**STAFF REPORT**  
**COMMUNITY DEVELOPMENT DEPARTMENT**

HEARING DATE: 5/19/2026  
TO: Mayor & City Council  
FROM: Nick Napoli, Associate Planner  
208-884-5533  
SUBJECT: Windrow No. 1  
FP-2026-0010

Final Plat consisting of eight (8) building lots and four (4) common lots on 4.82 acres of land in the R-8 zoning district for the second phase of Windrow Neighborhood Subdivision.

C. Landscape Plan ((dated: 03/04/2026))

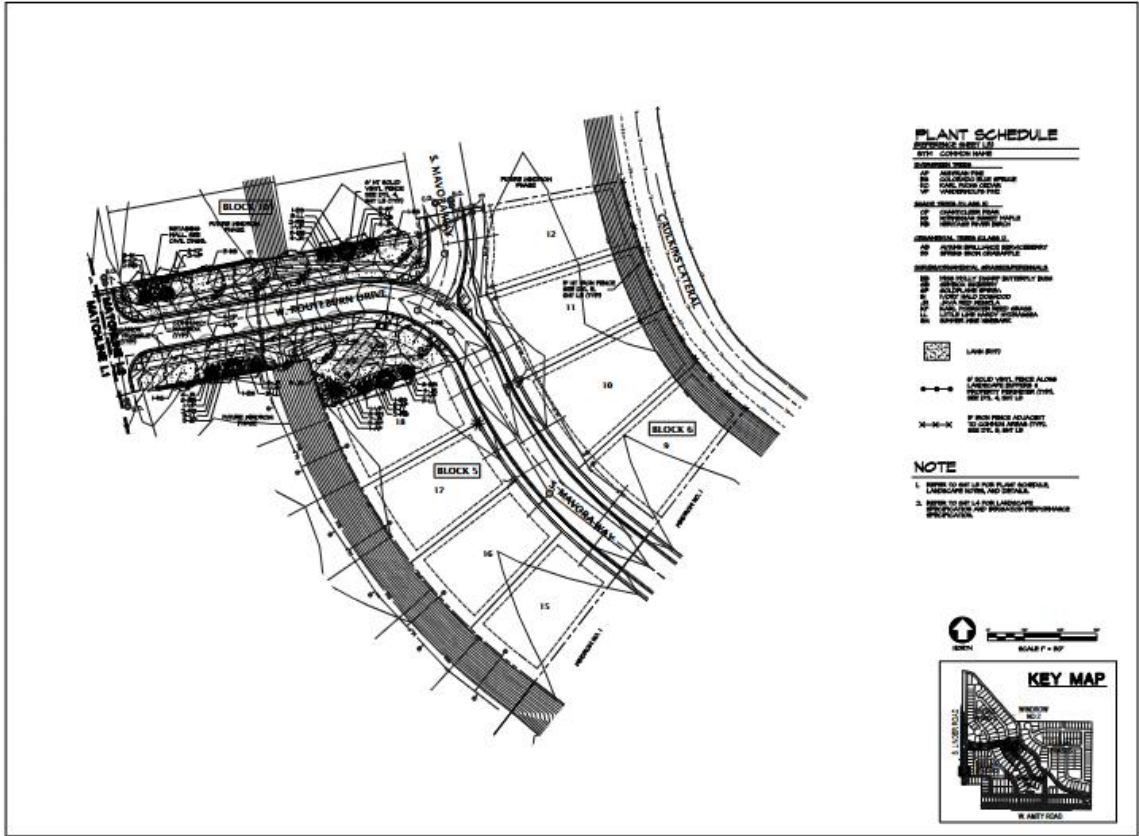
*A copy of the revised plat shall be submitted with the final plat for City Engineer signature.*
5. The landscape plan prepared by Jensen Belts, dated 4/11/2024, included in Section V.C, shall be revised as follows:

- a. Dimension the width of the multi-use pathway along Linder.
6. Off-street parking is required to be provided for all residential units in accord with the standards listed in UDC Table 11-3C-6 based on the number of bedrooms per unit.
